CUY-90-14.90

**NEORSD Walworth Run Relocation
(Reference Document)**

**Innerbelt Bridge
Construction Contract Group 1 (CCG1)**

- Addendum No. 10 - Revised drawings from NEORSD Addendum 3, revised plan sheets C1, C2 & C10 and revised Plan Information Sheet

PROJECT NO.:
SHEET: X
SCALE: 1"=40'
SHEET NO.: C-1

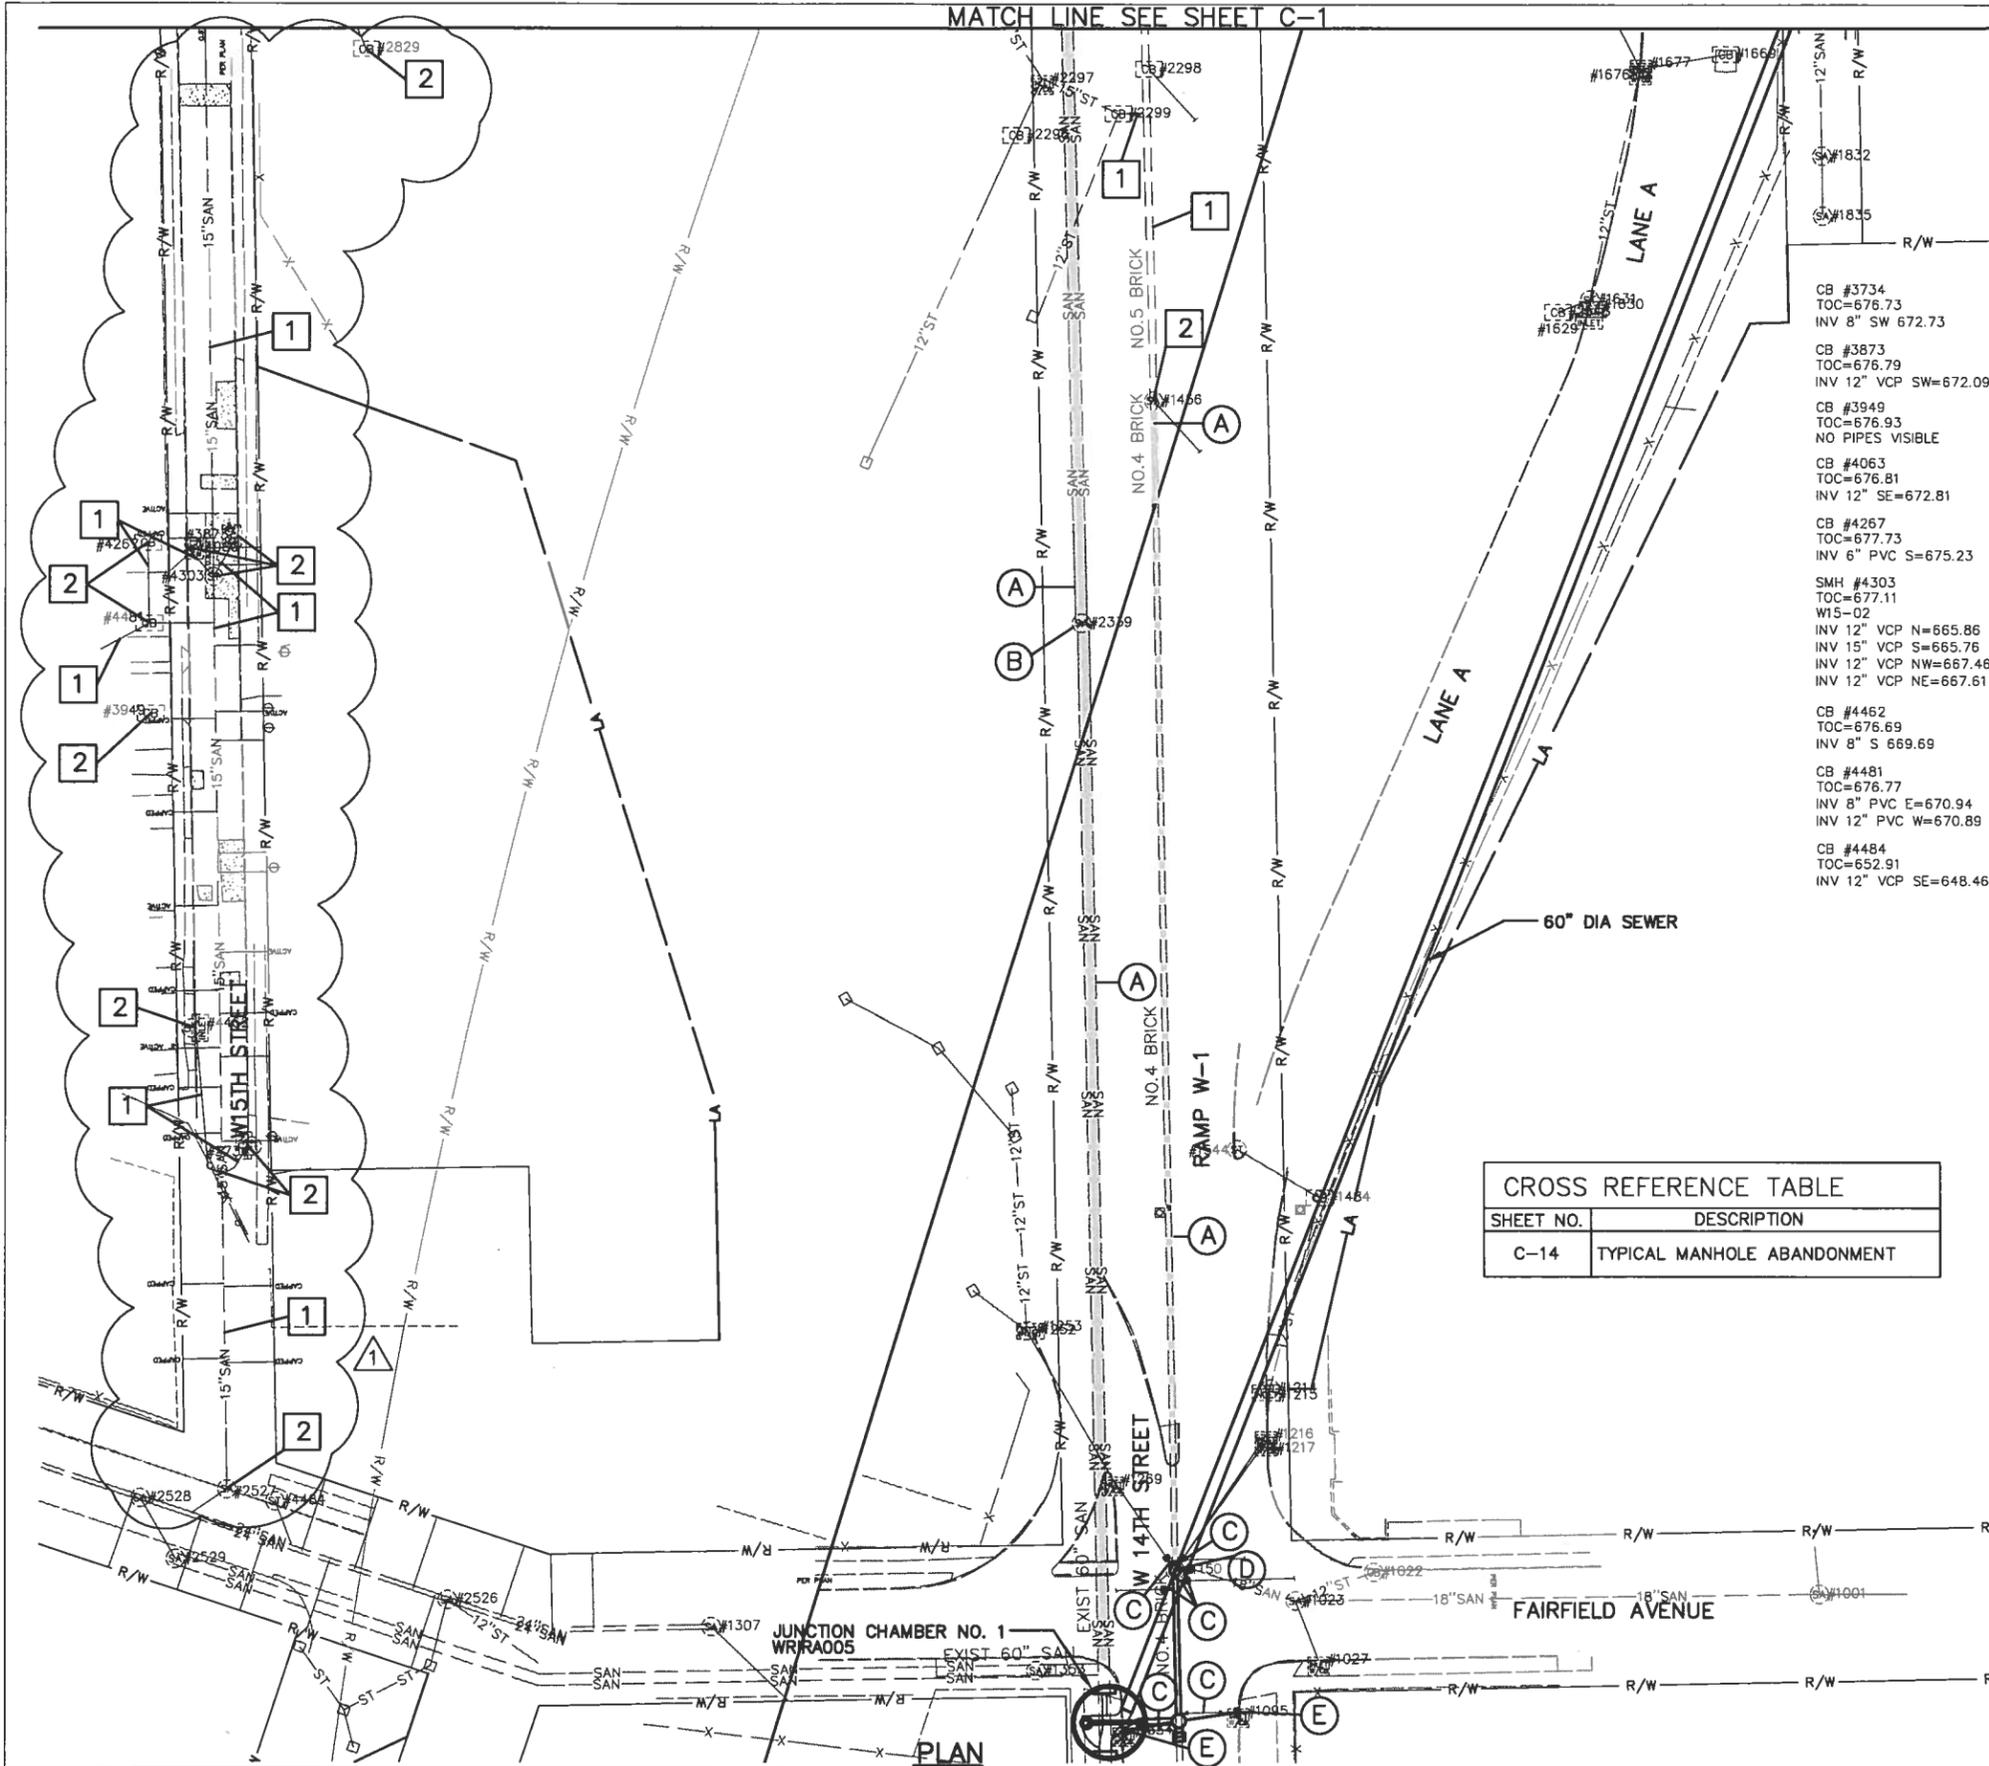
- 2. In the CROSS REFERENCE TABLE, **DELETE** the references and descriptions for "Sheet No. P-4" and "Sheet No. P-5"
- F. Sheet No. C-1
 - 1. **DELETE** this sheet in its entirety and **REPLACE** it with revised "Sheet No. C-1" that is included in Attachment 7.

PROJECT NO.:
SHEET: X
SCALE: 1"=40'
SHEET NO.: C-2

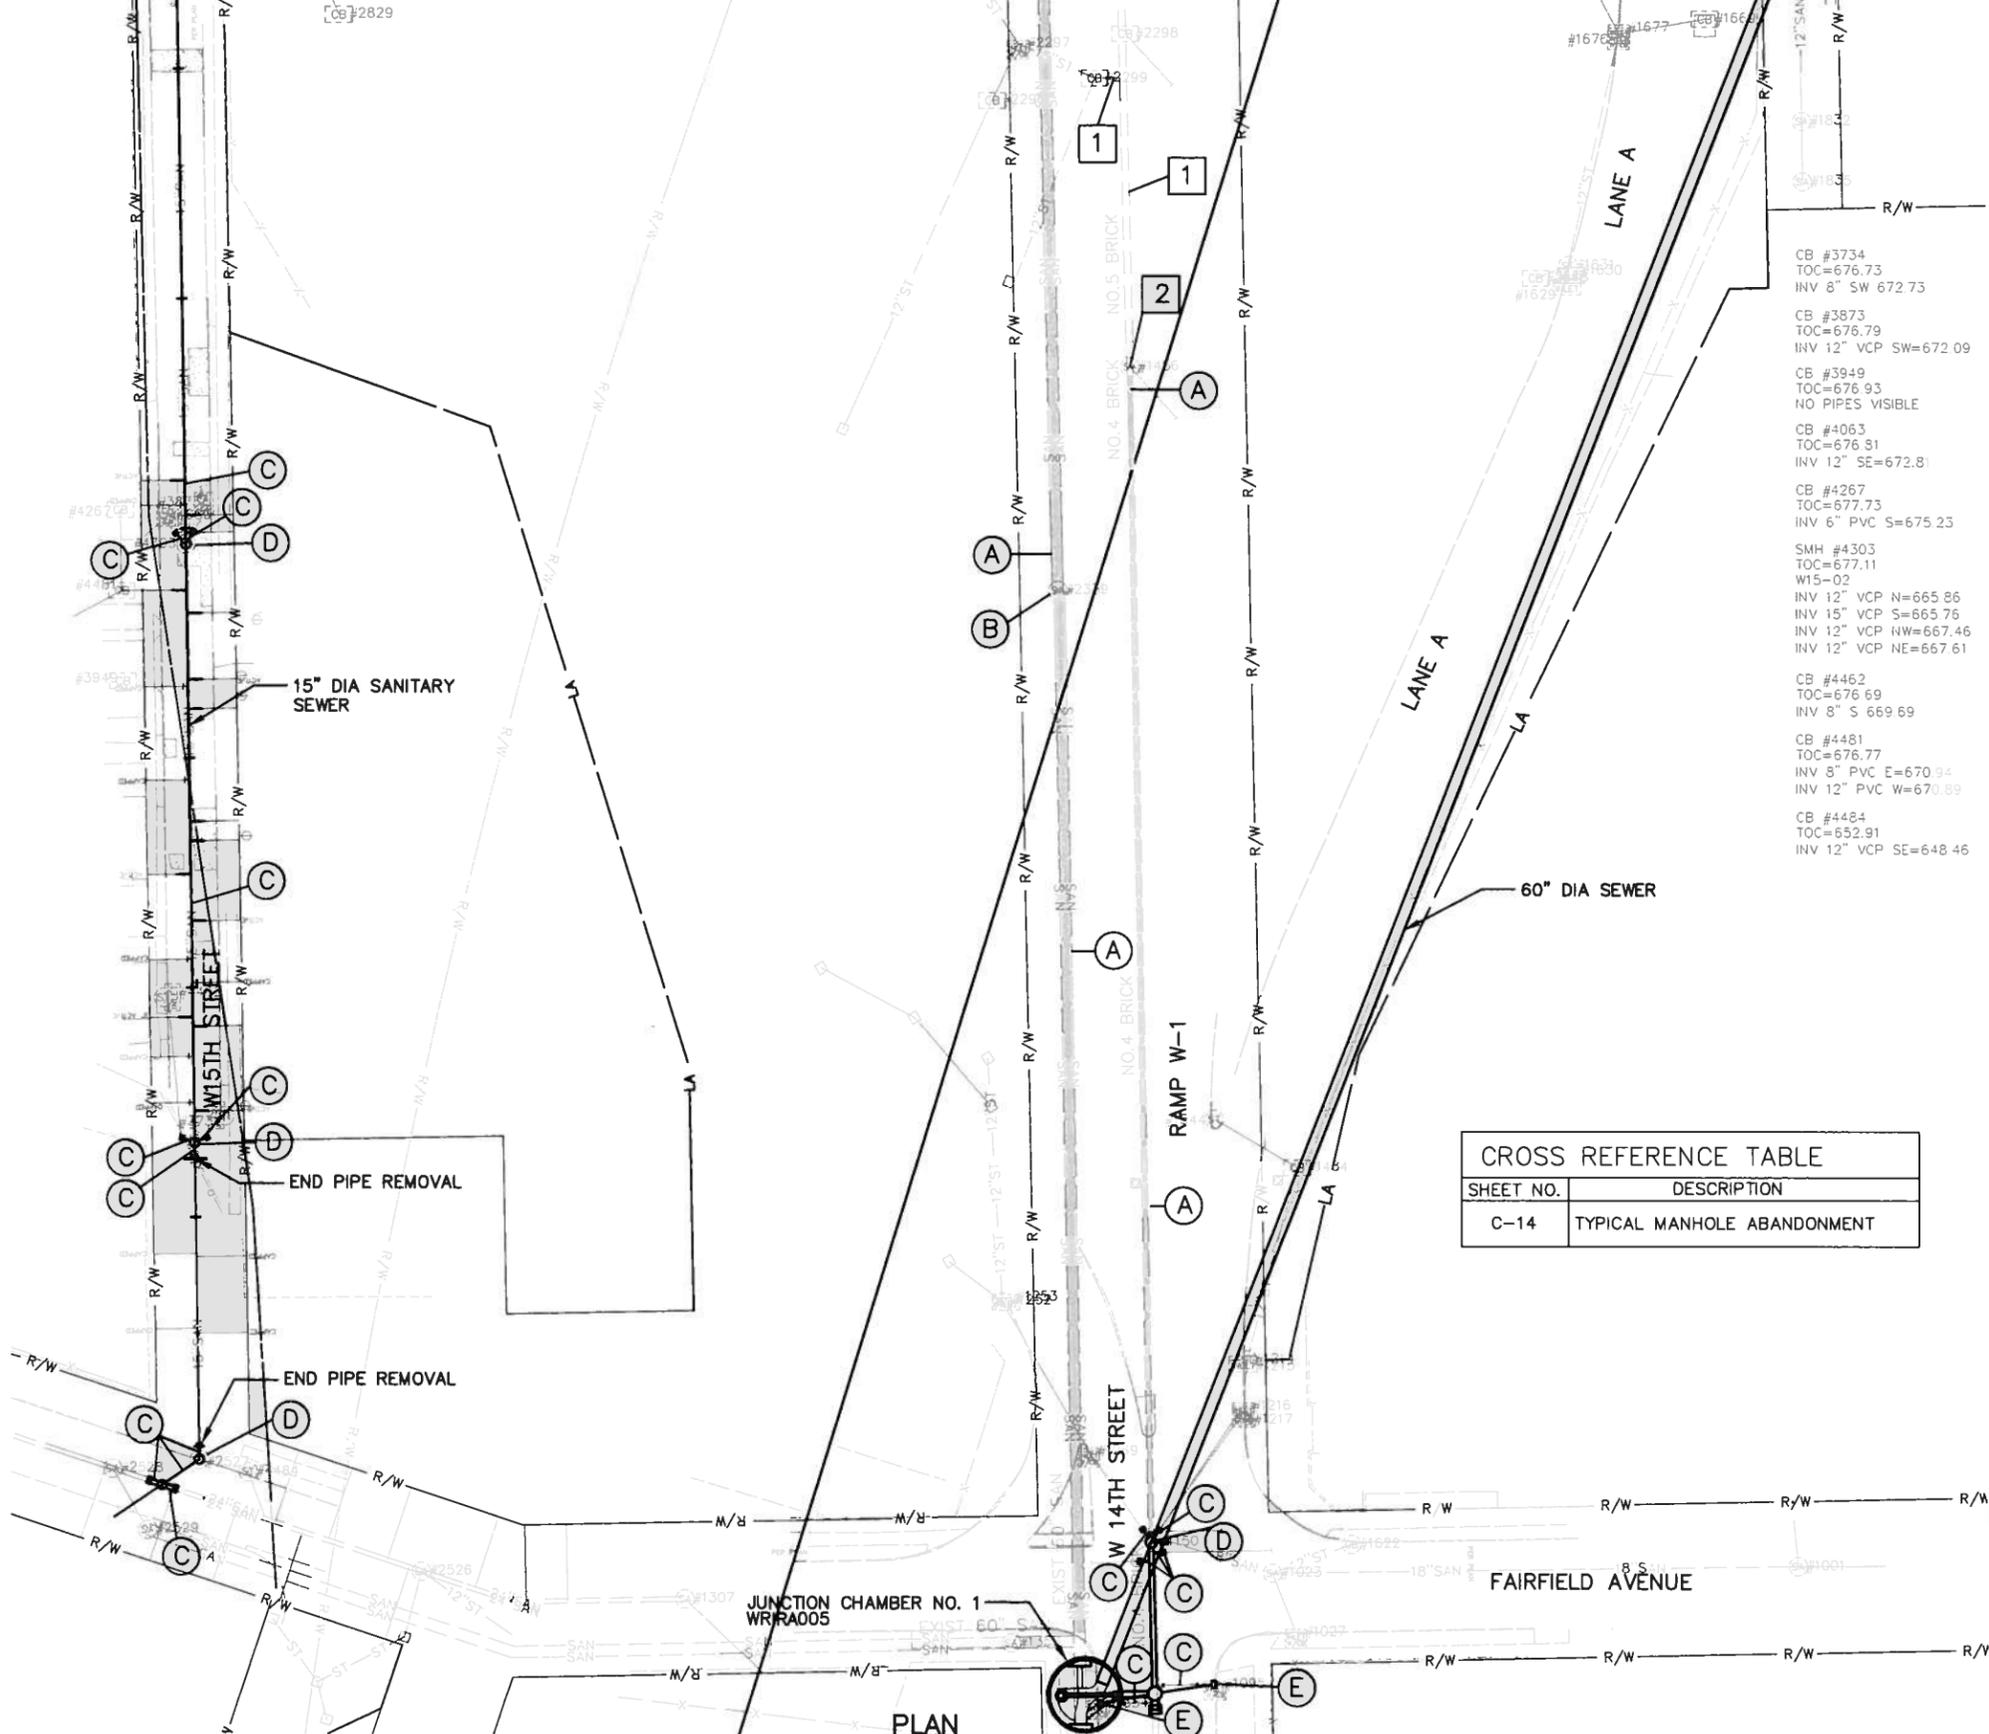
- G. Sheet No. C-2
 - 1. **DELETE** this sheet in its entirety and **REPLACE** it with revised "Sheet No. C-2" that is included in Attachment 7.
- H. Sheet No. C-10
